LOCAL HISTORIC DISTRICT: Dilworth

PROPERTY ADDRESS: 420 E. Park Avenue

SUMMARY OF REQUEST: Landscape Plan

Charlotte Historic District Commission - Case 2014-125

420 East Park Ave.
Charlotte, NC

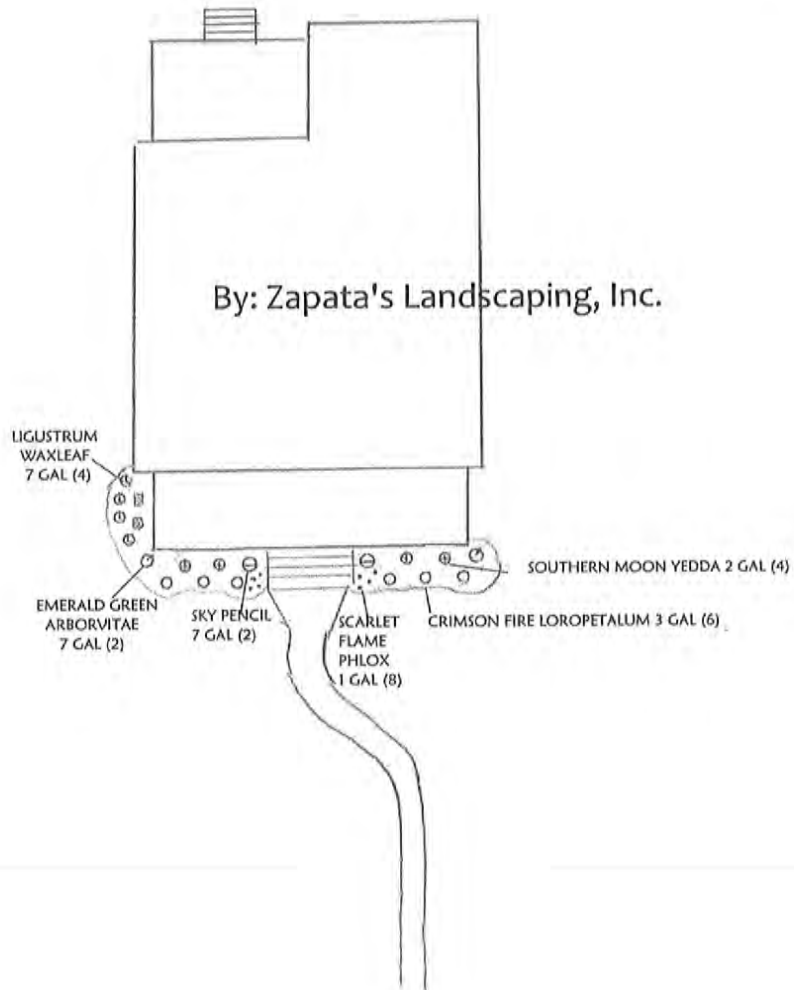
The proposal is to locate the HVAC units in the side yard and screened with evergreen shrubs. The area on either side of the front porch is defined as part of the side yard in the zoning ordinance.

The proposed landscaping plan meets the guidelines for screening mechanical units in side yards.
